### APPEAL SUMMARY

**Appeal ID:** 18784

**Project Address:** 3582 SE Powell Blvd

**Building/Business Name:** Powell Center

1 SITE PLAN  
1" = 40'-0"

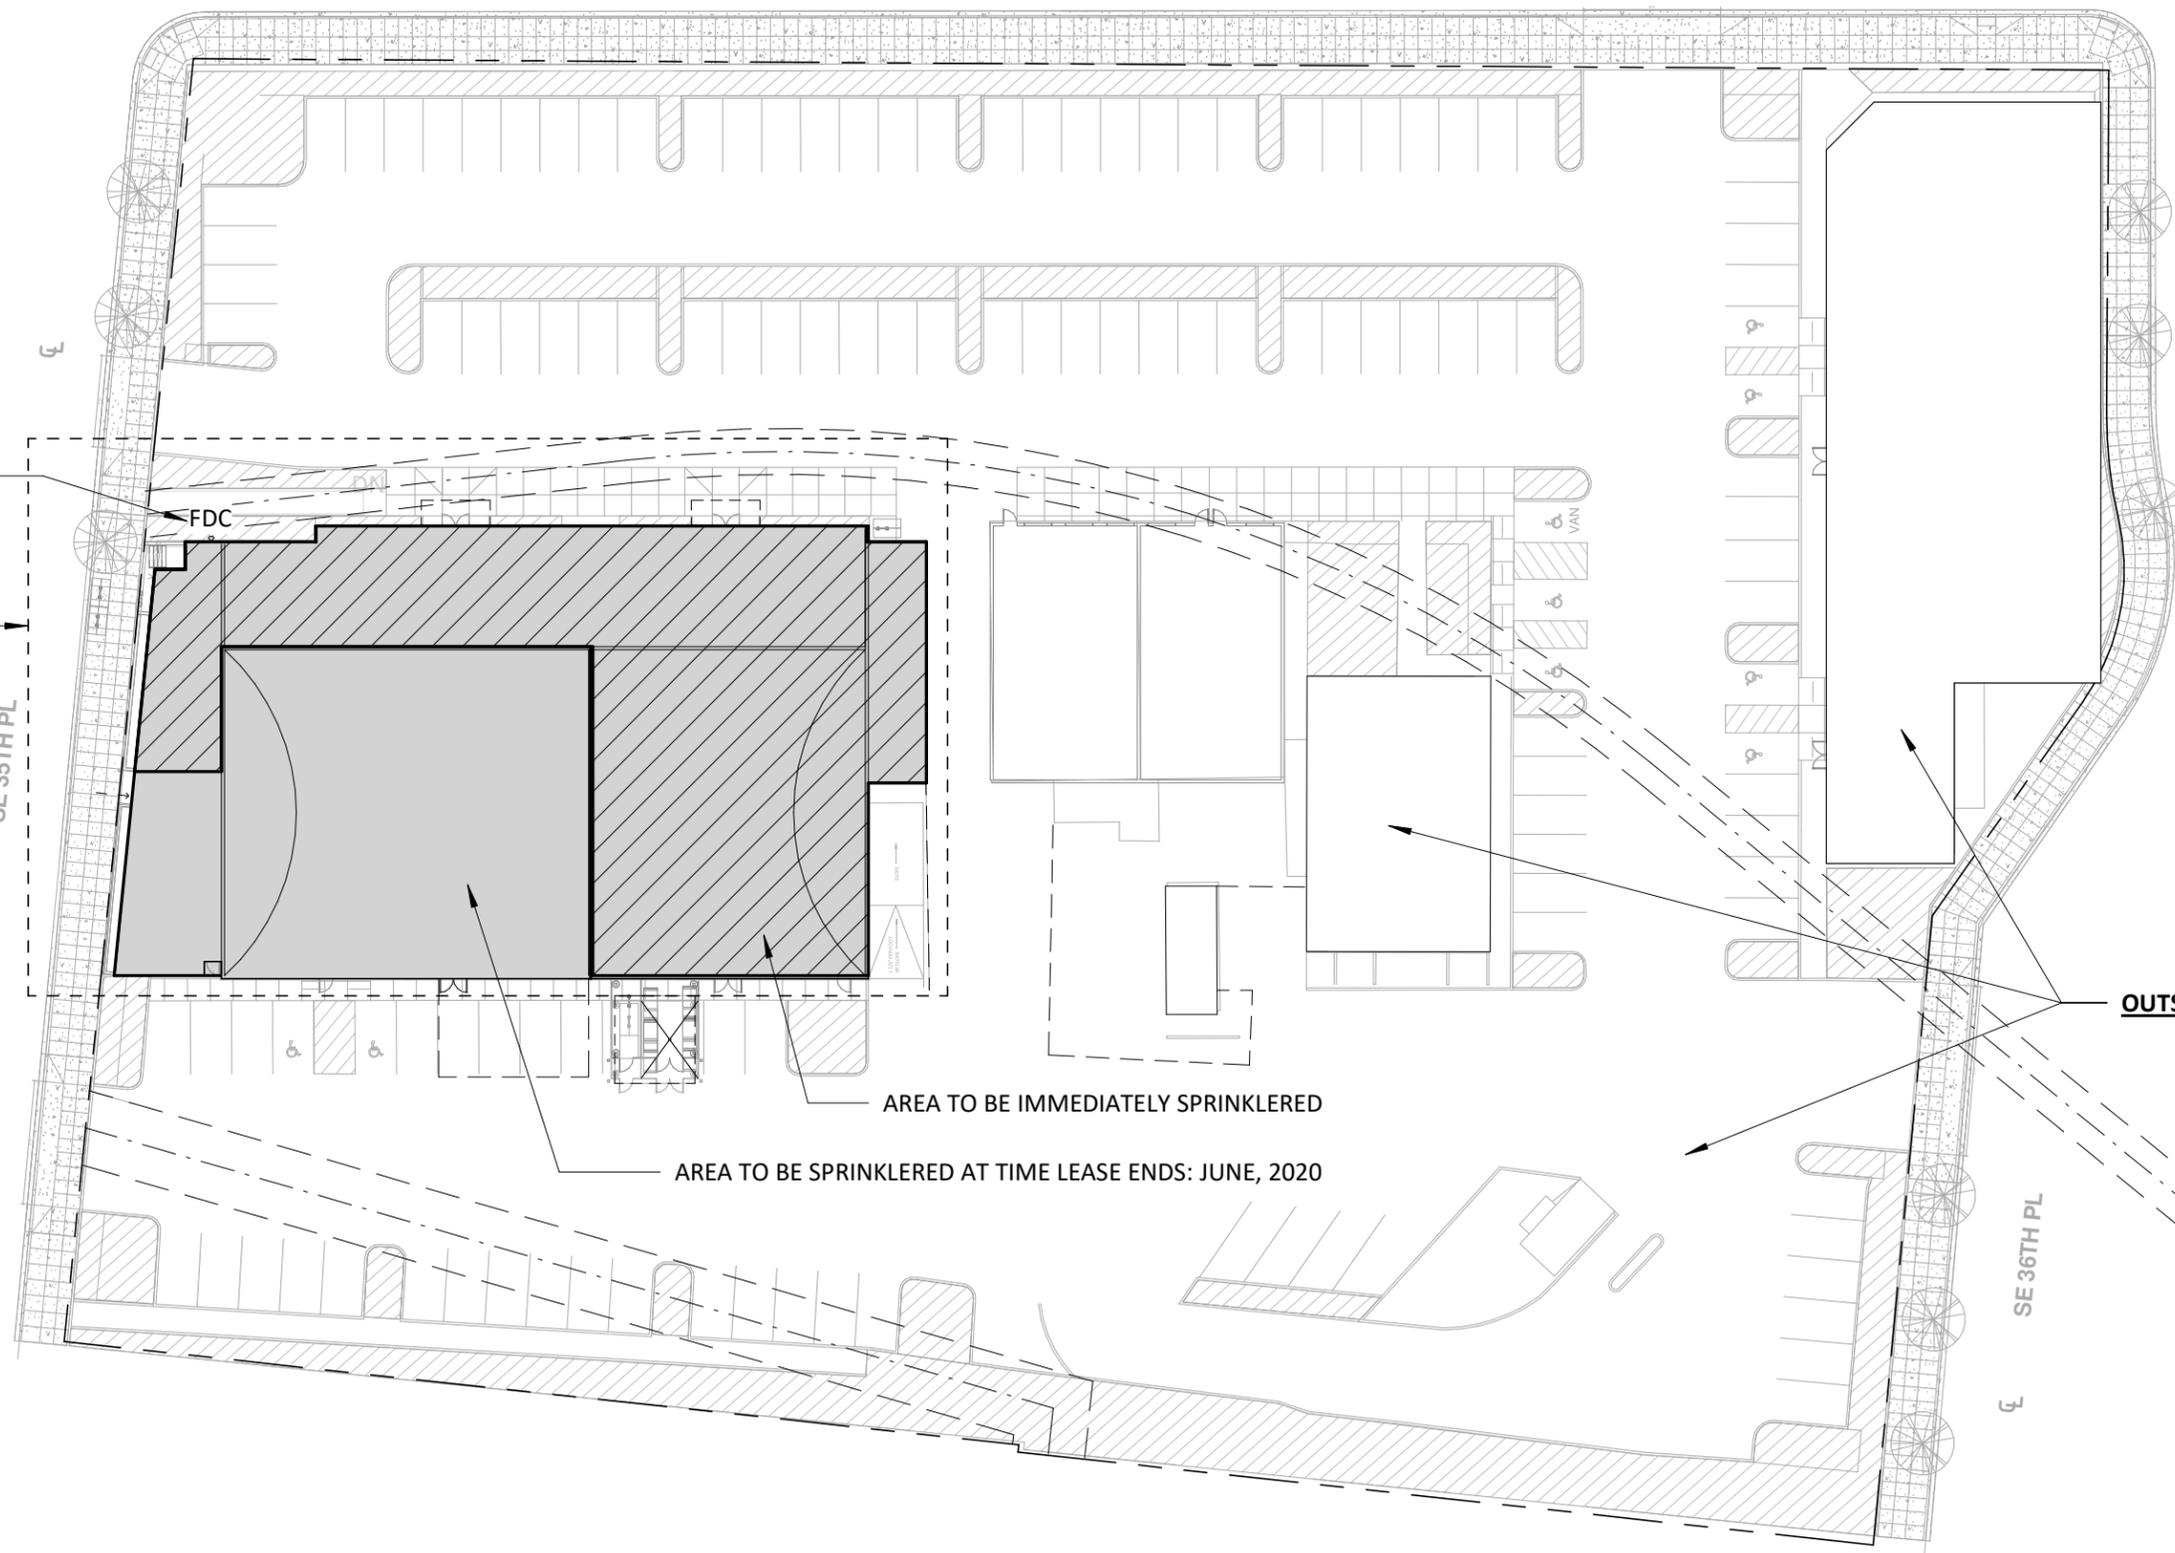
The existing one-story building has three tenant spaces – a 5,612 sf restaurant (A-2), a 4,150 sf workshop (F-1), and a 6,577 sf nightclub (A-2). The building structure is primarily concrete and masonry with a wood-framed roof. There are no sprinklers in the current building. Previous permits include 99-00234BLD. This permit shows a 2 hr wood-framed fire wall demising the nightclub and workshop. The 8" cmu exterior walls, and demising walls separating the nightclub and restaurant inherently provide a 2 hr fire rating per the National Concrete Masonry Association fire resistance ratings.

The new proposal will sprinkler and alarm the entire building and convert the workshop and part of the restaurant into a market and deli space, and turn the nightclub and the rest of the existing restaurant into a brewery and new restaurant. Final tenant occupancies will be a 6,380 sf market (M/A-2), an 8,526 sf restaurant/brewery (A-2/F-1), and a 666 sf office (B). However, the lease for the current nightclub does not expire until June, 2020 – 18 months from now. In order to not interrupt their lease or business operations, the sprinklers cannot be installed in their portion of the building until the occupants have vacated their tenant space. Until sprinklers can be installed in their space, the occupants of the nightclub are still protected by 2 hr fire walls, and are in no less safe a condition. In addition to the sprinkler scope, the structural design proposes to strengthen roof/wall connections, and provide a secondary support system for the existing concrete piers, thus making the entire building, including the nightclub, safer and stronger.

As an additional measure of safety we are proposing to decrease the spacing of the sprinkler heads along the demising walls of the nightclub to 6' on center (similar to a water curtain).

**Reason for alternative** The owner of the building wishes to begin improvements as soon as possible so that the unoccupied two thirds of the building do not sit vacant any longer. The property has become an eyesore and begun to attract acts of vandalism and homeless camping. In order to make improvements quickly, the owner wishes to renovate and upgrade the portions of the building which are currently unoccupied. This work includes new storefront, signage, structural upgrades, and sprinklers and fire alarm for the new retail spaces. Once the nightclub lease ends in 18 months, the complete upgrades can be done. At that time, sprinklers will be installed in the nightclub space and the entire building will be provided with NFPA 13 sprinklers throughout.

The work to be done immediately will create a safer, stronger building even though sprinklers cannot be installed in the entire building right away. Occupants will still be protected with the existing 2 hr fire wall construction, and will have further protection with increased sprinkler heads along the demising wall, and improved structural conditions. Thus, the occupants in the nightclub will be in safer conditions for the duration of their lease than they are currently.

For these reasons, we ask you allow the phasing of the entire sprinkler system to work around the existing tenant leases. Therefore, we kindly request the appeal be granted.

**Restaurant / A2 fire area over 5,000 s.f. with full building sprinkler system phased over two years. Granted provided final phase of sprinkler installation is completed before January 01, 2021.**

**Note: The entire building must be provided with sprinklers, either concurrent with the tenant finish slated for June 2020 or if the existing tenant remains by January 1, 2021.**

**The phased sprinkler agreement must be reviewed and approved by the Fire Marshal's Office. Appellant may contact Corey Stanley (971 291-8919) with questions.**
